APPROVALS		DATE	 Wulfsberg Electronics Division A Chelton Group Company 6400 Wilkinson Drive Prescott, AZ 86301			
DRAWN	<i>Leslie Ewart</i>	5-23-02	SERVICE BULLETIN, WSB C-5000-9, OPTIMIZED DUAL-MIC SOFTWARE			
CHECKED	<i>Dale Crivato</i>	5-23-2002				
ENGINEER	<i>Scott Brock</i>	5-23-2002	SIZE	CAGE CODE	DWG NO.	REV
ISSUED	<i>V. Wallace</i>	05/21/02	A	1B7G3	150-040495	B
			SCALE: NONE		DO NOT SCALE DRAWING

SERVICE BULLETIN

BULLETIN NUMBER: WSB C-5000-9

This software update adds the optimized dual MIC operation. See Appendix A for a detailed list of changes.

Figure 1. Screw Locations to Remove C-5000 Bottom Cover

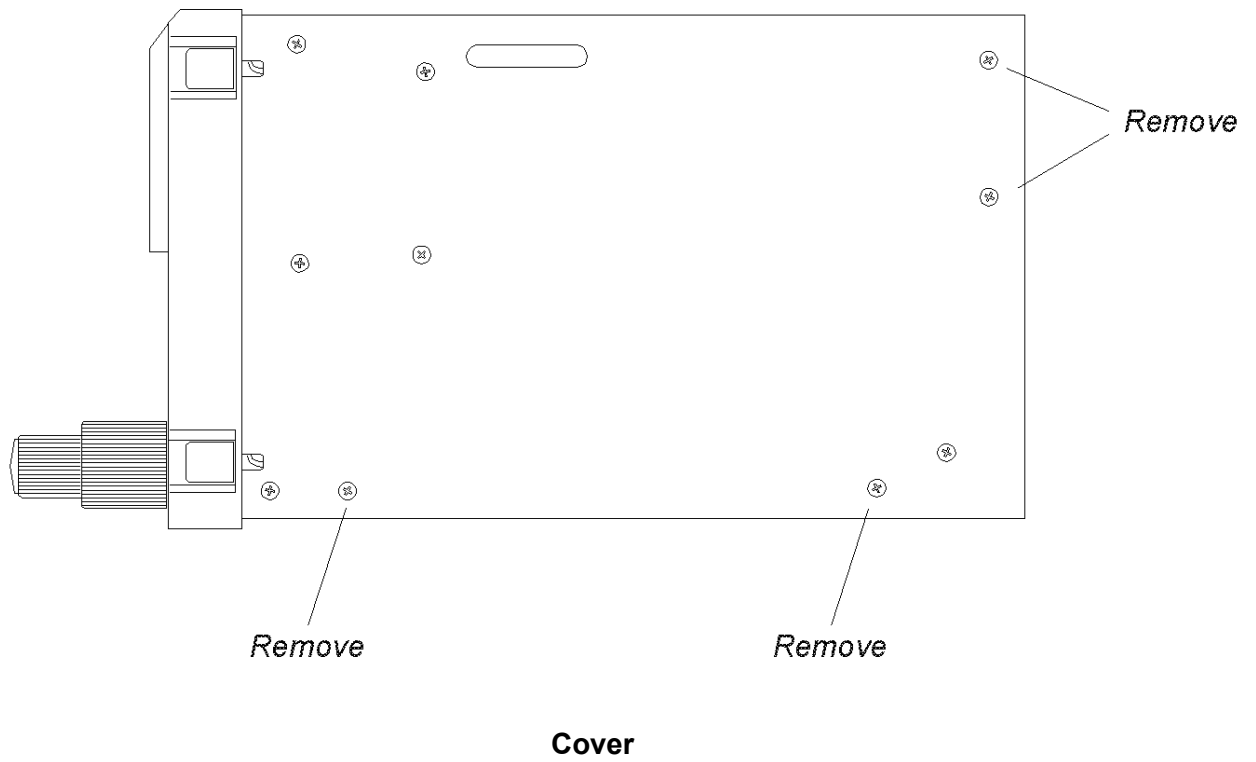
1. Remove the bottom cover of the C-5000 to access the Main Board. The bottom cover is secured to the chassis by eight Phillips-head screws, four located on the left side and four located on the right side of the unit. See Figure 1.
2. Remove EPROMS U201, P/N 106-816662-XX, and U208, P/N 106-816664-XX. See Figure 2.
3. Install updated EPROMS U201, P/N 106-816662-16, and U208, P/N 106-816664-16.
4. Verify U304 is marked as 106-816663-06. U304 should already be –06 if U201 and U208 were –12 or higher. If not, replace it with item 1A. (This item is not included in standard kit)
5. Remove the rear cover and 300-016290-01 SERIAL RT INTERFACE Board.
6. Verify U25 is marked as 106-816929-06. U25 should already be –06 if U201 and U208 were –12 or higher. If not, replace it with item 2A. (This item is not included in standard kit)
7. Reassemble and secure the C-5000.
